FINAL DRAINAGE REPORT for

Legacy Church
10460 W Hwy 24,
Green Mountain Falls, CO

PCD File No. PPR1933

Prepared: July 19, 2019
Resubmitted: September 17, 2019
Resubmitted: October 18, 2019
Resubmitted: November 22, 2019

UD-Detention, Version 3.07 (February 2017)

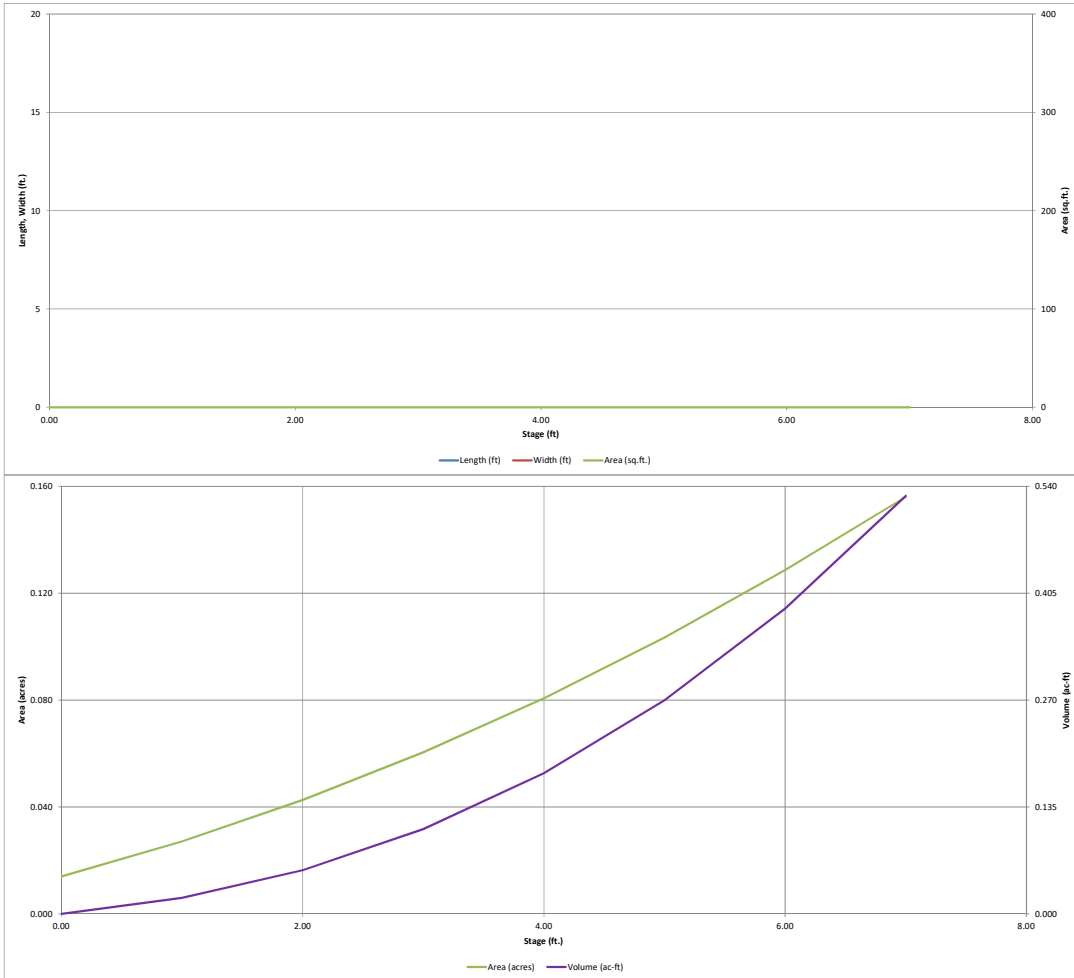
Having such a small opening will be susceptible to clogging. Consider revising the outlet designs. If you decide to keep this design, additional text shall be provided in the drainage report and the O&M indicating that you are aware that the small opening is susceptible to clogging, that additional maintenance will be required and that the pond should be closely monitored.

The pond details indicate 4 ft. Please revise so that they match.

the pond detail shows the invert at 0.33" below the basin bottom. Revise so that they match.

UD-Detention, Version 3.07 (February 2017)

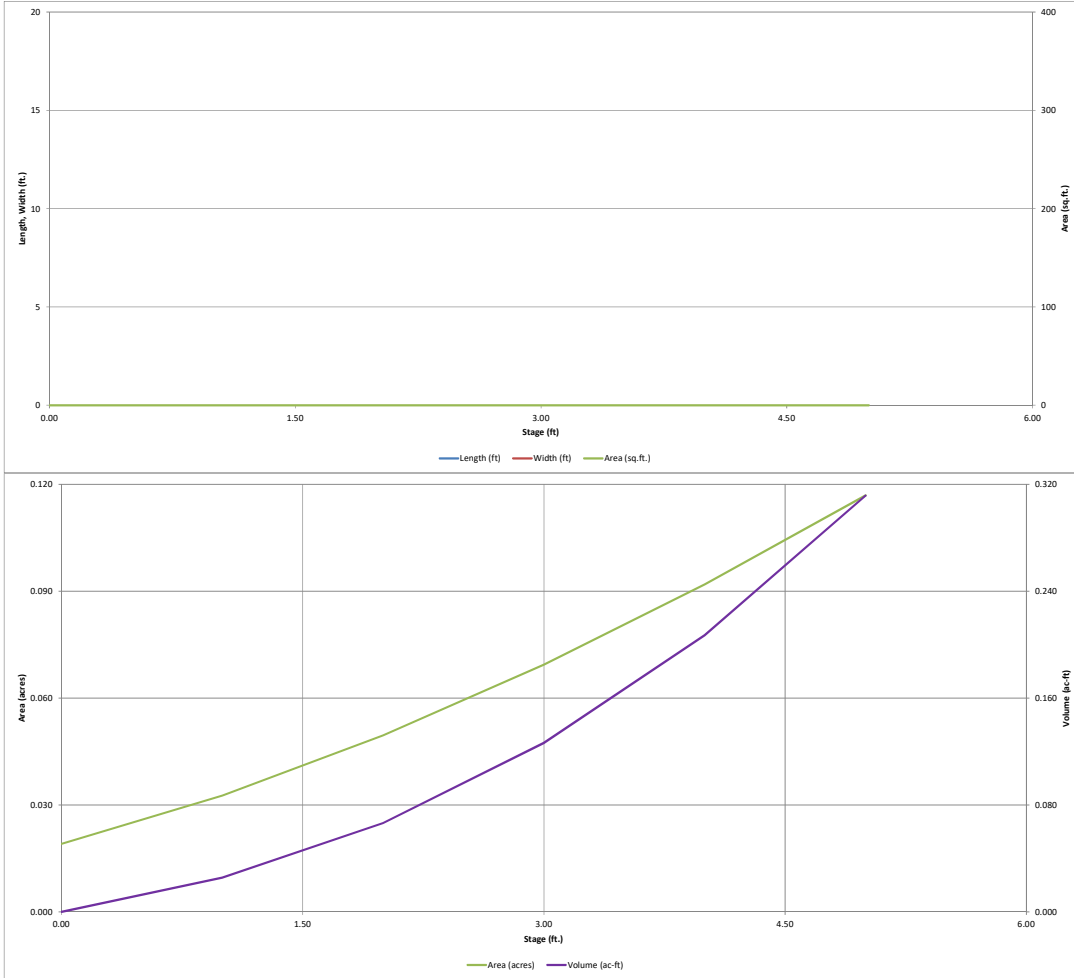
The pond details indicate 4 ft. Please revise so that they match.

the pond detail shows the invert at 0.33" below the basin bottom. Revise so that they match.

See comment on east pond calculation.

REV: 11/22/19
 REV: 10/18/19
PROPOSED DRAINAGE PLAN
SHEET 2 OF 3

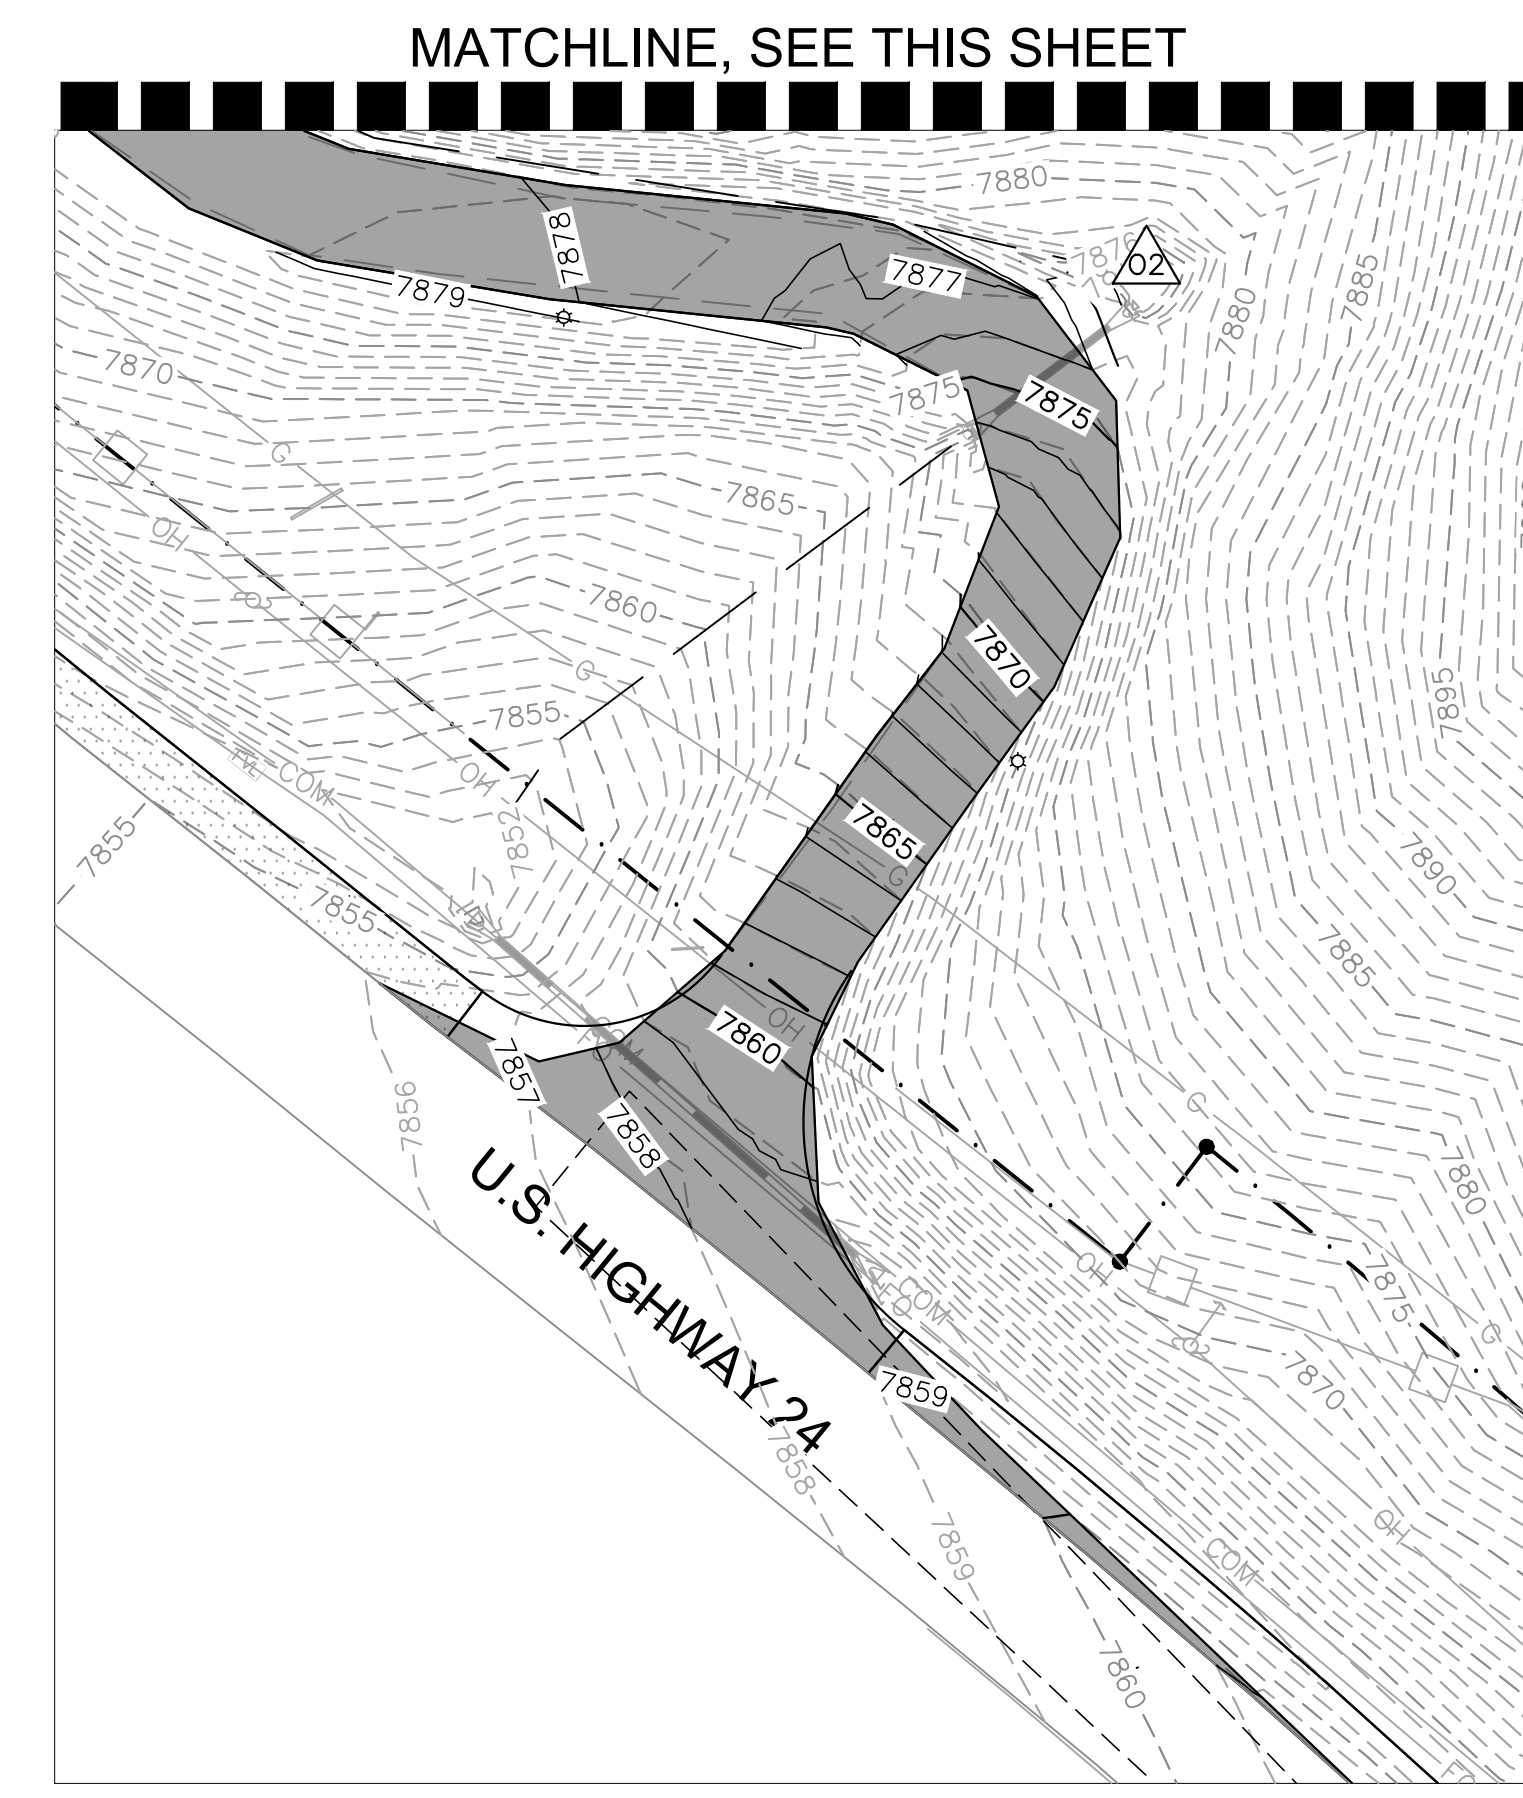
per comments from CDOT please show the location of the proposed septic system.
